Safety Recall Trucks

Date	Group.	No.	Page
06.11	SC0354		1(11)

Battery Cable Routing and Clipping

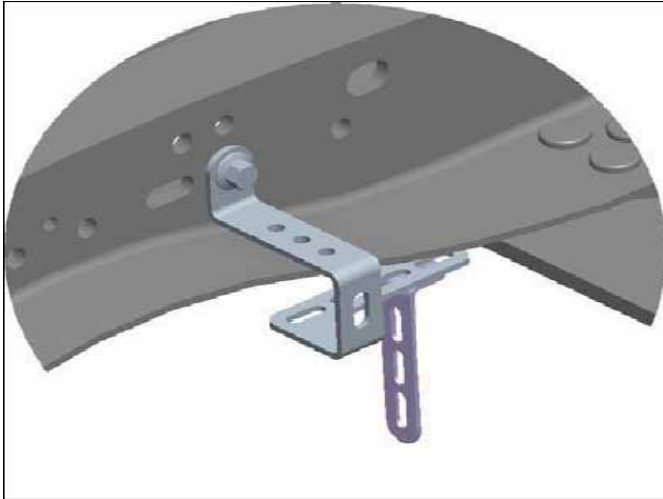
On certain fleet vehicles the battery cables may contact chassis mounted bolts, which in extreme cases where the insulation is compromised, may cause a vehicle fire.

15. Remove the existing bracket on rear of transmission and install new bracket part number 965565 and plastic cable clamps as shown.

16. Install spacers as needed in between fixed bracket locations.
Note: This will allow for proper spacing and reinforce the battery cable clipping.
